DART SERVICE INSTRUCTION

TO AMEND INSTALLATION INSTRUCTIONS D350-607-3 Rev.D,
INSTALLATION INSTRUCTIONS D350-607-4 Rev. C AND
INSTRUCTIONS FOR CONTINUED AIRWORTHINESS ICA-D350-607 REV. 6

REF TCCA STC: SH94-14

A	NEW ISSUE	AJS	14.05.16
REV.	DESCRIPTION	BY	DATE
DESIGN	AJS	DART AEROSPACE LTD HAWKESBURY, ONTARIO, CANADA	
DRAWN	AJS		
CHECKED		DRAWING NO.	REV. A
MFG. APPR.	N/A	DSI 9699	SHEET 1 OF 2
APPROVED		TITLE	SCALE
DE APPR.		LUG REPLACEMENT	NTS
DATE	14.05.16	COPYRIGHT © 2014 BY DART AEROSPACE LTD THIS DOCUMENT IS PRIVATE AND CONFIDENTIAL AND IS SUPPLIED ON THE EXPRESS CONDITION THAT IT IS NOT TO BE USED FOR ANY PURPOSE OR COPIED OR COMMUNICATED TO ANY OTHER PERSON WITHOUT WRITTEN PERMISSION FROM DART AEROSPACE LTD.

FIGURE 1: INSTALLATION OF D4775-041 FWD STRUT

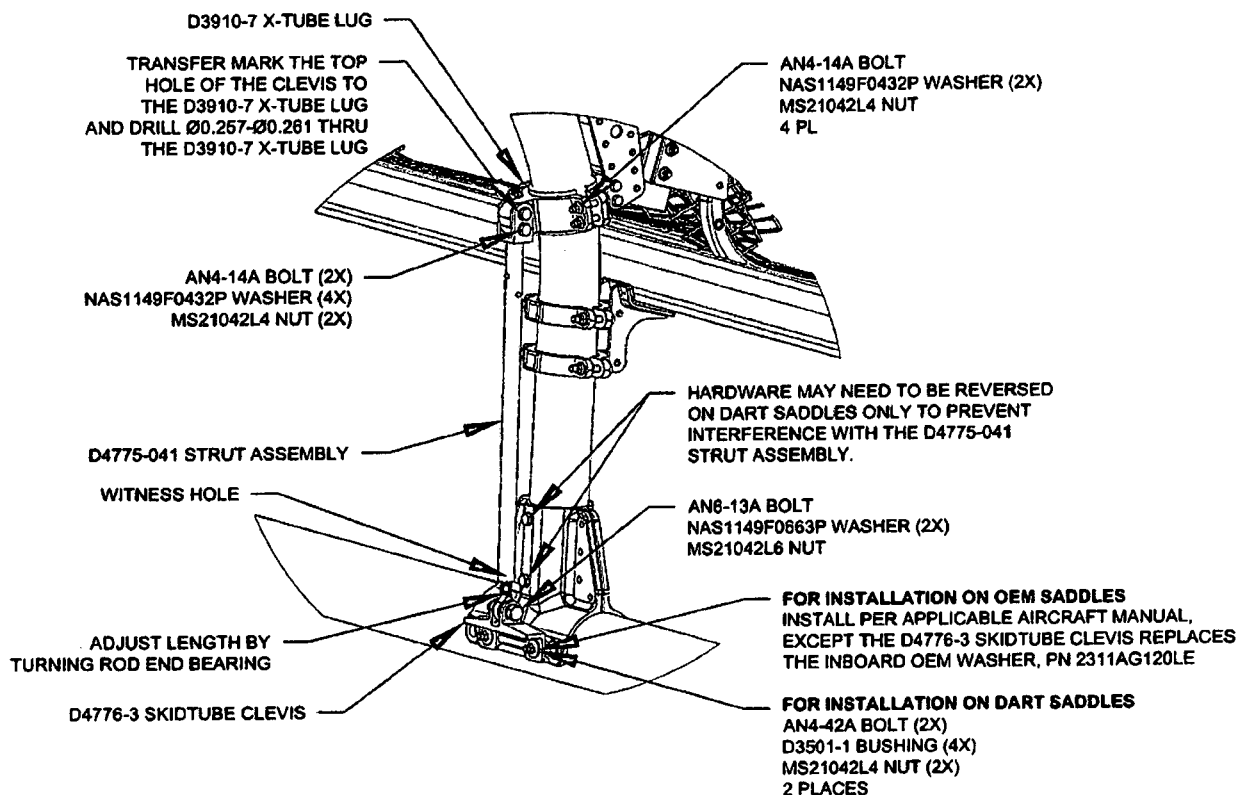
- 3.1 Substitute the Forward Lower D3910-5 X-Tube Lug with the D3910-7 X-Tube Lug as shown in Figure 1.
- 3.2 Install the forward D4775-041 Strut Assembly. Transfer mark from the upper hole on the clevis of the D4775-041 Strut Assembly to the D3910-7 X-tube Lug and drill thru the lug $\varnothing 0.257$ - $\varnothing 0.261$ as shown in Figure 1. Touch up chemical conversion coating per MIL-DTL-5541. Check the witness holes located at the bottom end of the D4775-041 Strut Assemblies to ensure that the thread from the rod end extends past the witness hole.
Torque MS21042L4/-4 nuts to 50-70 in-lbs (5.7-7.9 N-m). Torque MS21042L6/-6 nuts to 160-190 in-lbs (18.1-21.5 N-m).
- 3.3 Complete the installation in accordance with Installation Instructions D350-607-3 Rev. D or D350-607-4 Rev. C.
